Access Compliance Report

Public Rights-of-Way

(Curb Ramps)

Intersection ID: N/A	Main Street: WAVERLY_WALK_AV	Cross Street: SIX_MILE_CREEK_RD	Location: SE
ADA ID: 7AA217074962	Ramp Type: Perp	Initial Pass/Fail: Fail	Overall Compliance: No
			Severity Score: 21.25

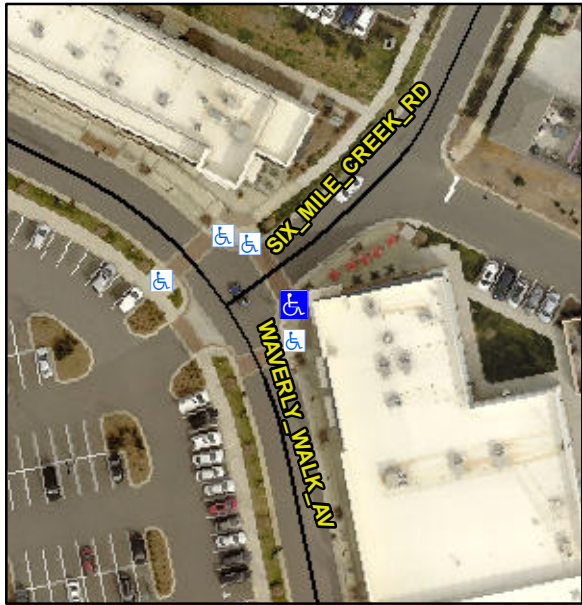
Codes/Mitigation Info/Possible Solution			Field Measurements/Component Compliance					
	Possible Solutions:		Compliance	Description	Data	Compliance	Description	Data
	Remove & Replace Entire Ramp.		N/A	Ramp Length (in)	83.0	No	Ramp Slope (%)	8.7
			No	Ramp Width (in)	47.5	Yes	Ramp XSlope (%)	1.0
			N/A	Flare Type LT	N/A	N/A	Flare Type RT	N/A
			N/A	Flare Slope LT (%)	N/A	N/A	Flare Slope RT (%)	N/A
			N/A	Flare Traversable LT?	N/A	N/A	Flare Traversable RT?	N/A
			N/A	Landing Length (in)	N/A	N/A	DWS Provided?	N/A
			N/A	Landing Width (in)	N/A	N/A	DWS Contrast?	N/A
			N/A	Landing Slope (%)	N/A	N/A	DWS Length (in)	N/A
			N/A	Landing X Slope (%)	N/A	N/A	DWS Full Width?	N/A
Surveyor Notes:		N/A	N/A	Landing Curb? (Y/N)	N/A	N/A	DWS Offset (in)	N/A
PROW/ADA:		Not Found, R304.5.1, R304.2.2	N/A	Shared Landing?	N/A			
			N/A	Gutter Ponding?	N/A	N/A	Gutter Slope (%)	N/A
			N/A	Gutter Lip Ht (in)	N/A	N/A	Gutter X Slope (%)	N/A
